RFI RESPONSE

REG. REF. LRD22A/0930

Dalguise House, Monkstown, Dublin 16, Dún Laoghaire Rathdown

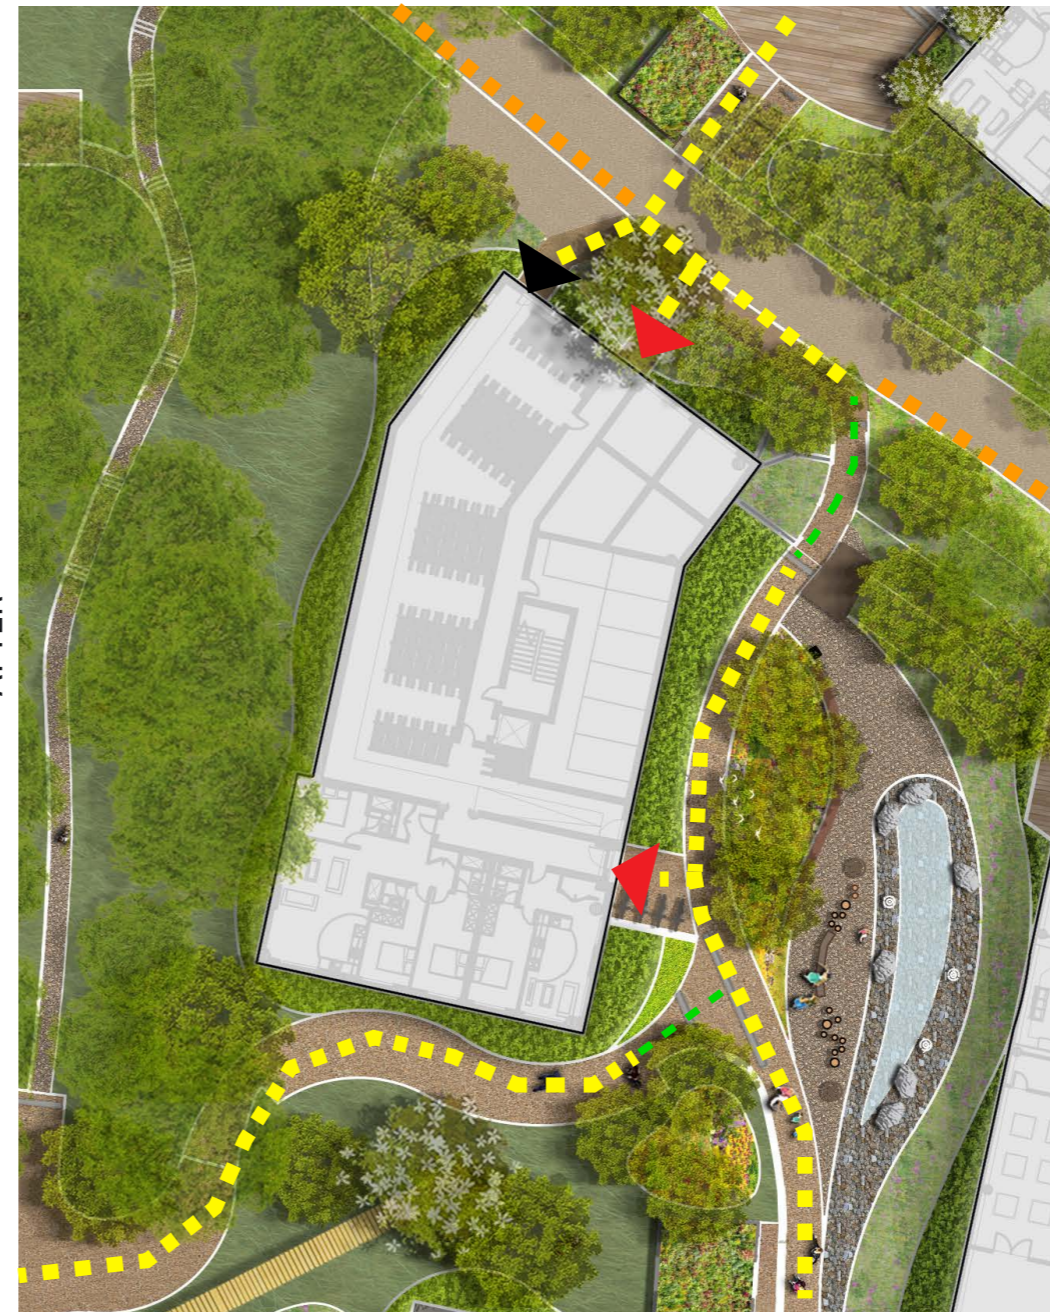
... I. Access to surface level cycle parking to the south of Block D is via adjacent steps, loose bark chips with steps, or alternative longer and more onerous route via the Dalguise house building. ...”

<p>l. Access to surface level cycle parking to the south of Block D is via adjacent steps, loose bark chips with steps, or alternative longer and more onerous route via the Dalguise house building.</p>	<p>Basement cycle parking is accessible via level entrance from the north, while external bike shelters are accessible from the south., However all external steps will also be fitted with a bike rail where an immediate alternative level access is not available.</p> <p>Please see landscape GA and Access diagram, as well as breakdown of plans of pg.31.</p> <ul style="list-style-type: none"> • C0135 L301_ Landscape General Arrangement Ground Floor - Combined Plan • C0135 L9001_ Pedestrian Access Digram
<p>m. Set down area at Block E does not provide direct pedestrian access to Block E.</p>	<p>Direct access is now provided.</p> <p>Please see landscape GA and Access diagram, as well as breakdown of plan on pg. 32</p> <ul style="list-style-type: none"> • C0135 L301_ Landscape General Arrangement Ground Floor - Combined Plan • C0135 L9001 Pedestrian Access Strategy

Please see landscape GA and Access diagram, as well as breakdown of plans adjacent.

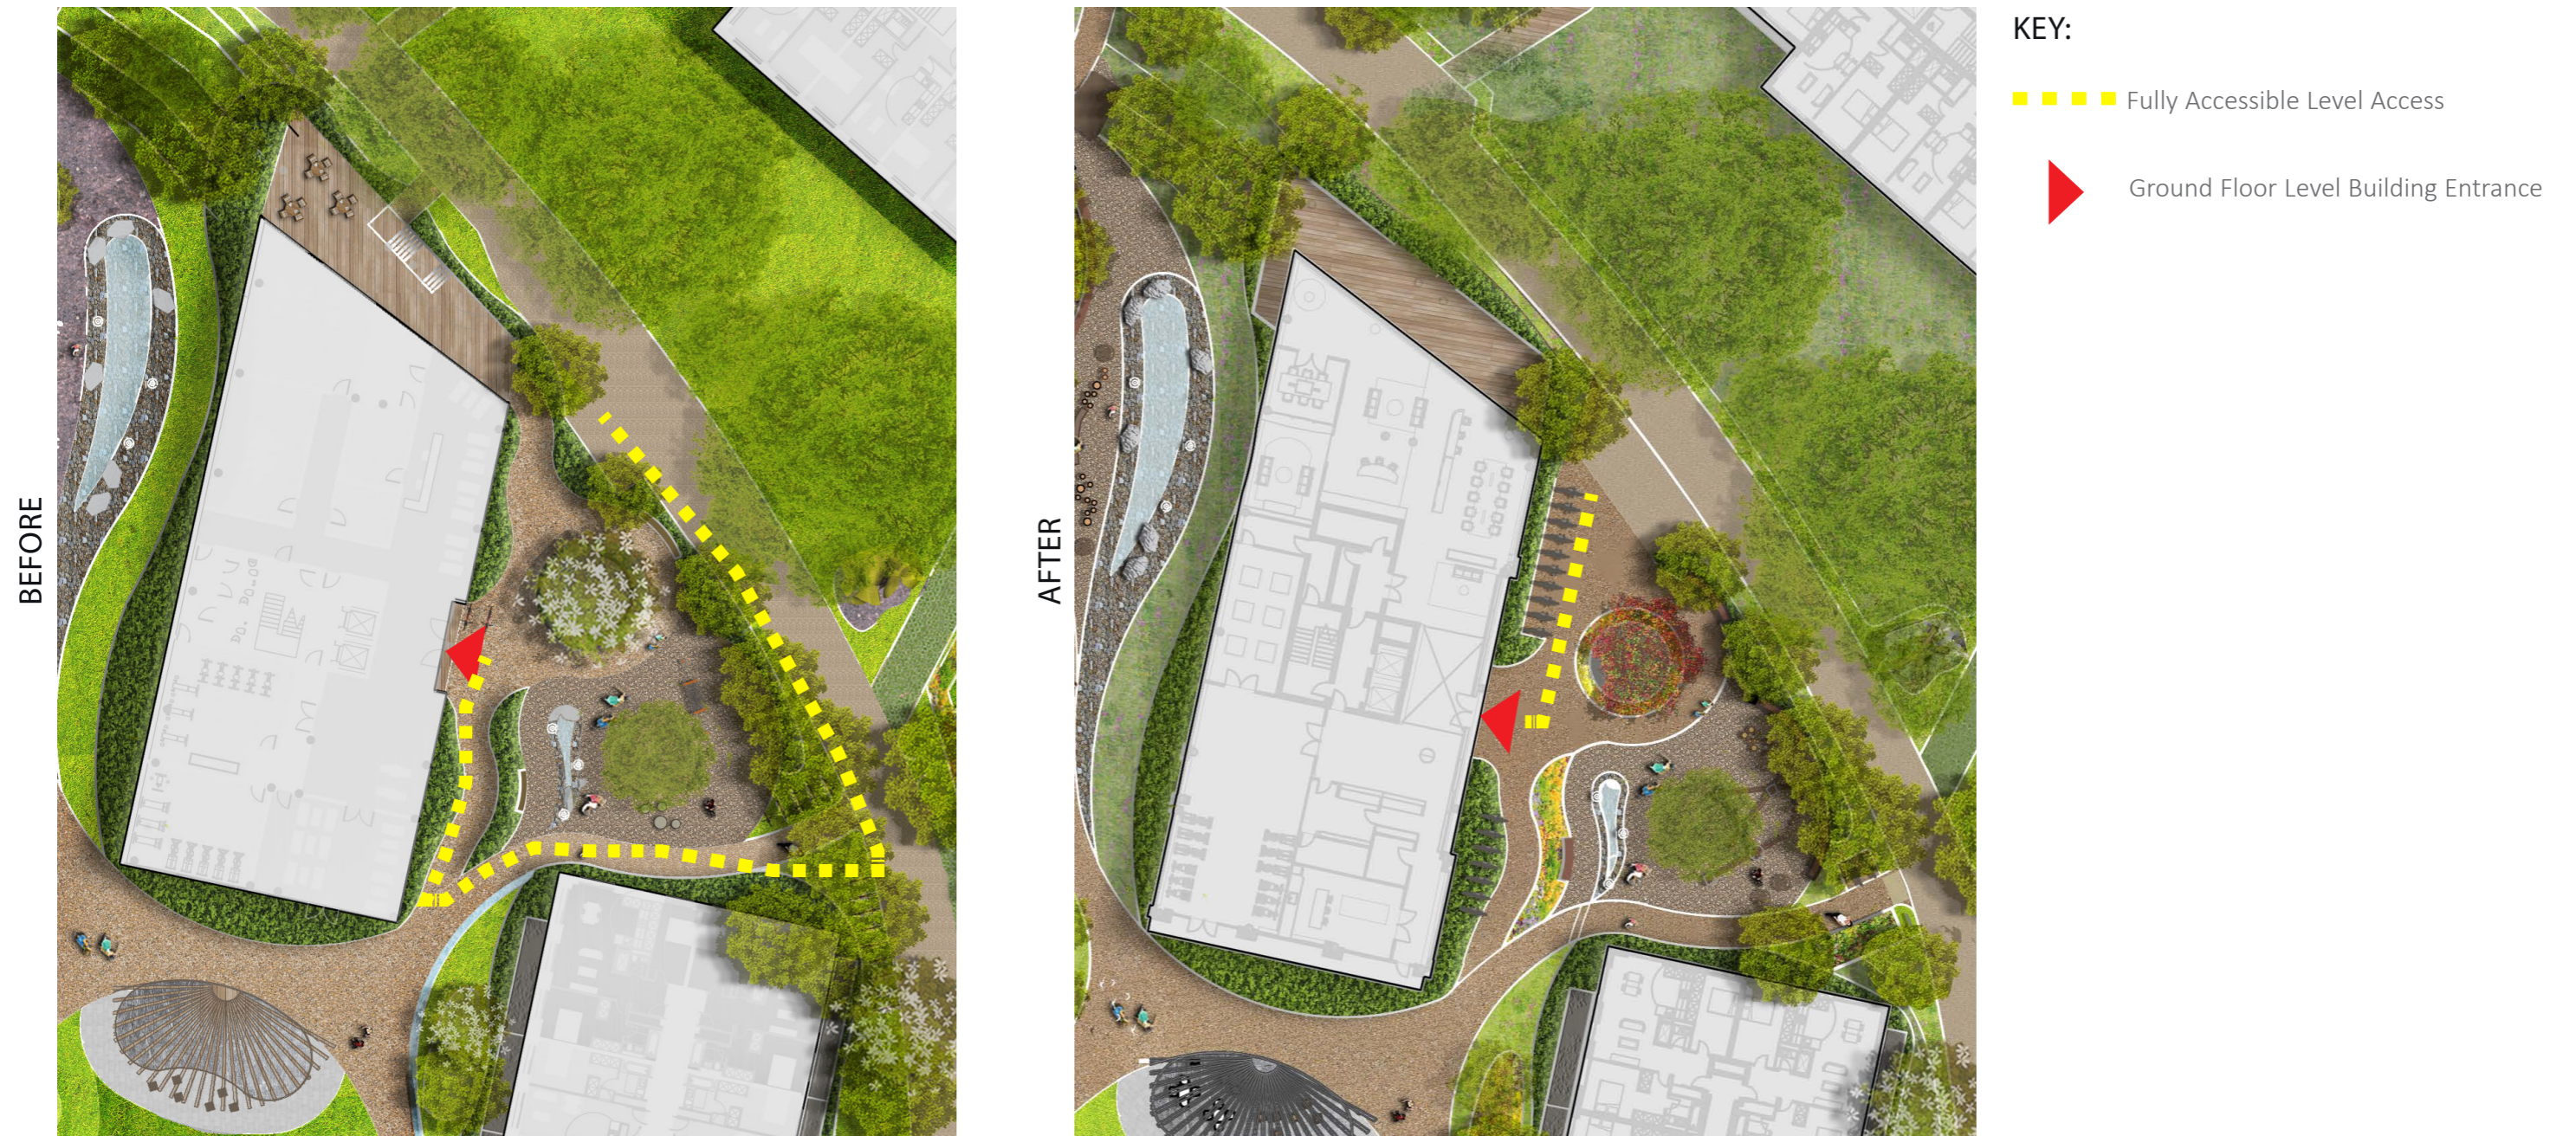
... m. Set down area at Block E does not provide direct pedestrian access to Block E. ...”
